Certificate of Appropriateness

1239 E. BRADY ST.

PTS ID 115035 COA: Overall remodel

Proposed Arlington Place Wood Fence Screen

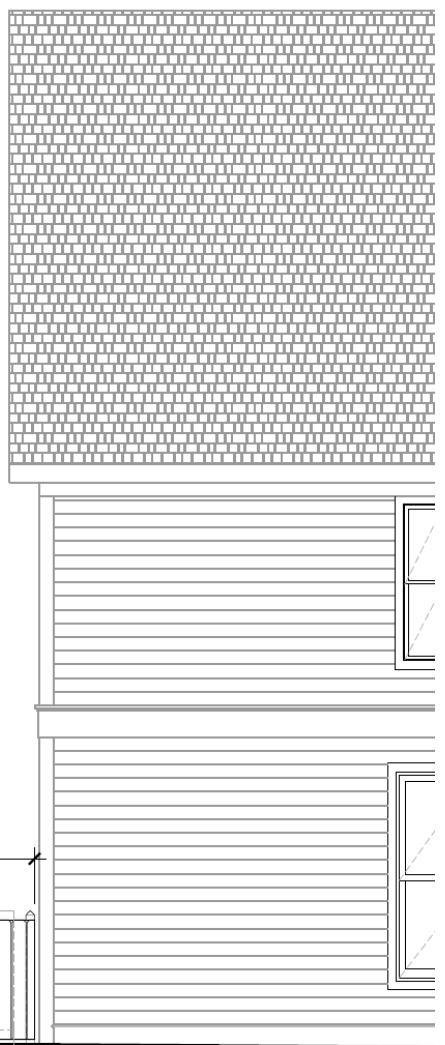
INSTALL ON BOARD PAINTED 48" HIGH WOOD FENCE AND GATE SYSTEM TO SCREEN TRASH & RECYCLING CONTAINERS AND HOOD MAKE UP AIR UNIT SEE PLAN FOR LOCATION
